STAFF RECOMMENDATION

NCPC File No. 6713

WASHINGTON CANAL PARK

September 24, 2009

Revised concept design for Washington Canal Park

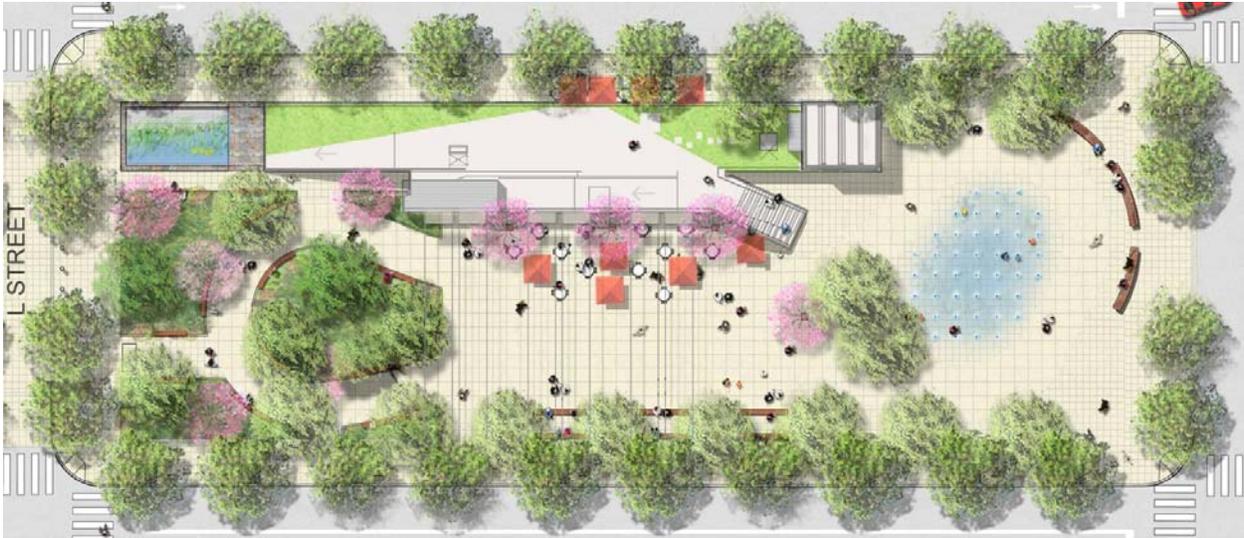
While the success of Washington Canal Park is to some degree dependent upon seamlessly integrating three separate city blocks into a unified whole, it is important that this be done in a manner that does not result in unnecessary intrusions into the historic L'Enfant rights-of-way that exist within the project area. Careful consideration needs to be given to the views and visual quality along these streets when designing and locating park pavilions, placing features along the curbside, and selecting paving materials. The width and visual openness of these rights-of-way should be maintained.

The design of the southern block pavilion must be given careful consideration so as not to overwhelm the other elements of the park. Including a venue similar to what is found in the National Gallery of Art Sculpture Garden will provide a strong focal point and prominent gathering space within the park. However, its design should not be so unique that it loses its relationship with the rest of the park and instead becomes a stand alone feature located on the edge of the park. The scale and massing of the pavilion should express the same simplicity that is characteristic of the overall design of the park, while its architectural detail can remain modern and similar to the other two pavilions. Furthermore, the inclusion of a second story observation post could create problems related to maintenance and public safety. Therefore, prior to advancing the idea of a second level, considerable thought should be given to the actual programming and monitoring of this space.

As proposed, the southern edge of the park has no real definition and lacks a sense of entry. As the "urban" edge to the park this end could be embellished, and delineated more from the sidewalk and street right-of-way, in order to give visitors a sense of detachment from the traffic along M Street, SE and the commercial uses that exist along this corridor.

Due to the different programmatic elements distributed throughout each of the three blocks, pedestrian safety while moving between blocks will require careful consideration and attention to detail. Staff is pleased to see that the revised concept plan maintains K and L Streets, SE for both pedestrian and vehicular travel. In order to ensure the safety of pedestrians when crossing these streets, the applicant should incorporate design features that naturally lead pedestrians to designated crosswalks and discourage mid-block crossings.
